Re: Zoning Application/Development Plan Amendment
05-02 (Commerce Bank in Wheaton)

To: Elsabet Tefaye, MNCPPC
From: Virginia Sheard, Kensington View Civic Association, Land Use and Zoning Work Group
Re: DPA 05-2, Application of Commerce Bank

Kensington View CA Statement on DPA 05-2 12 December 2005

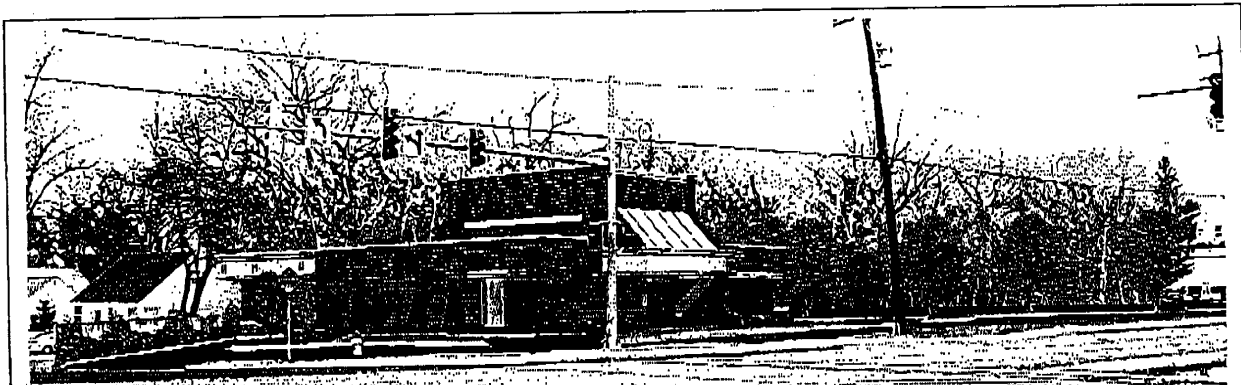
- o 58 am peak hour trips; 154 pm peak hour trips
- o "Not all of these trips would be new trips added to the public street network. A portion of these trips will be 'pass-by' trips." All northeast trips will be new to Valley View (no pass-by trips.)
- o Northeast entrance (75%) is only accessible from Valley View (page 17)
- o Current Valley View (page 8): am 0 in 2 out; pm 6 in 8 out
- o Commerce development: am 44 cars in/out; pm 116 cars in/out
- o The drivethroughs will exit on Valley View
- o Where will these 116 pm peak hour cars stack on Valley View or on University Blvd. Eastbound?

- **Drivethroughs** behind building, 13.6 feet from residential side yards
 - Brings car noise, fumes into residential yards (cars will be idling while waiting for teller)
 - All drive through traffic exits on Valley View (only controlled intersection for neighborhood residents).
 - Does not meet CPTED guidelines supported by the Wheaton Redevelopment Office

Building style is conspicuously branded— is visually similar in design to the Wacovia Bank across University Blvd. in the Westfield Shoppingtown mall, any Burger King, and many other commercial uses with prominent glass in front. It does not reaffirm the residential character of the neighborhood as recommended in the Sector and it does not comply with the five required findings of the zoning ordinance.

Note the visual dominance of the proposed structure over the adjacent residence and the proximity of the drivethroughs to the residence, and the extent of the paving around the site that is common to commercial uses.

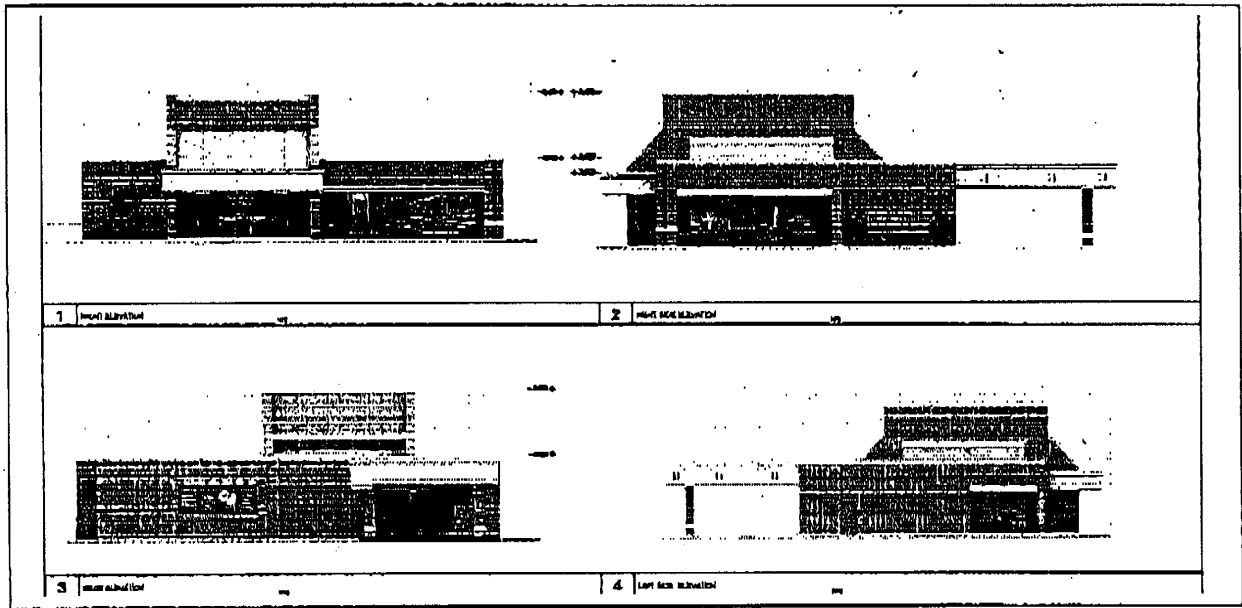
Smaller, multiple structures separated by green space, with less paved area visible from the front provides a more appropriate transition to the adjacent residential community.

The visual design of the proposed structure centered on a expansive paved area gives the impression a dominating commercial facility rather than a transitional use between commercial and residential.
